**ZILKER NEIGHBORHOOD ASSOCIATION COMMENTS (12 SEP 2019)
TO THE CITY COUNCIL ON 211 SOUTH LAMAR PUD REZONING**

EXHIBIT 2

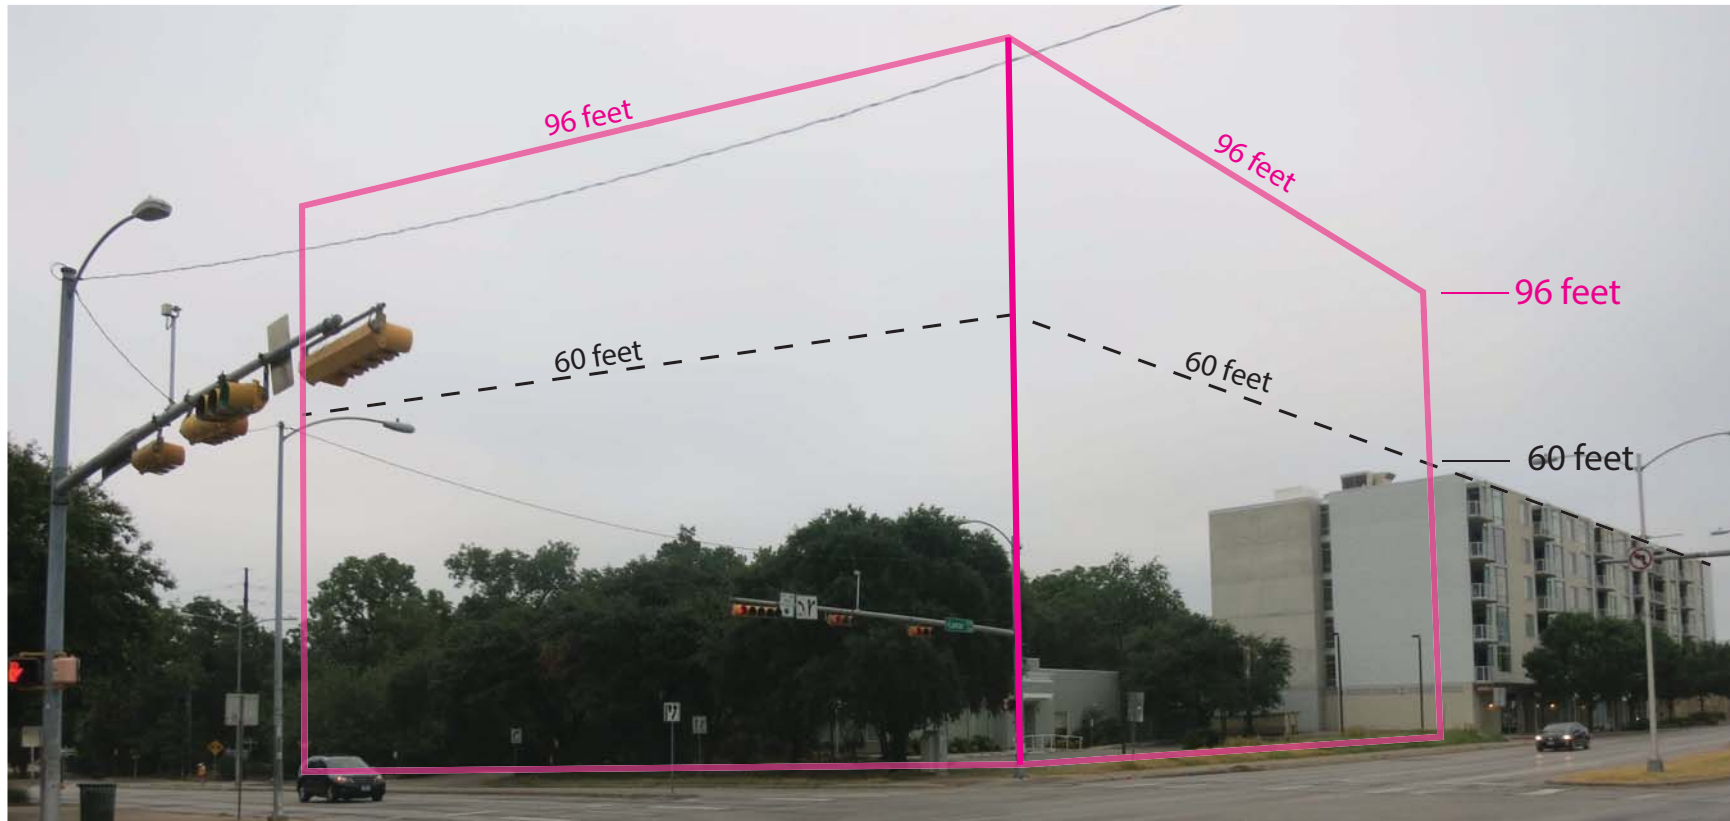
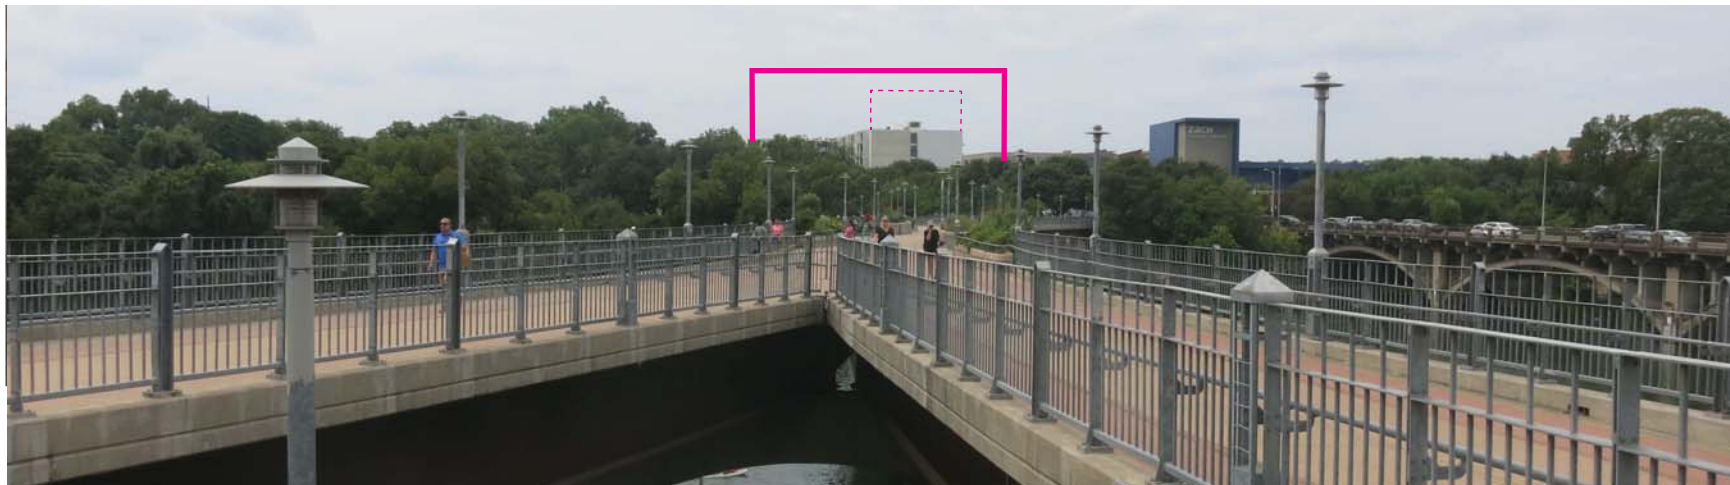
In theory, the original project had a maximum height of 96 feet for building block one and 78 feet for building block two; the new project is even higher with building block one remaining at 96 feet but building block two increasing by eight feet to 86 feet. Thus, this proposed project is inferior to the original project because it is even taller. This building will dominate the view along Butler Shores and the southern view from the Pfluger Pedestrian Bridge as one crosses Lady Bird Lake (see Exhibit 1). It will loom over the Butler Pitch and Putt Golf Course where the view still feels like a park setting, but it will not feel like a park setting when a 96-foot glass building looms over the northern end of the course (see current view from Butler Pitch and Putt in Exhibit 2).

Current View from the North End of Butler Pitch and Putt (looking west)
Much of the sky between the red lines behind the trees along Lee Barton Dr in this photo will be replaced by a view of the hotel
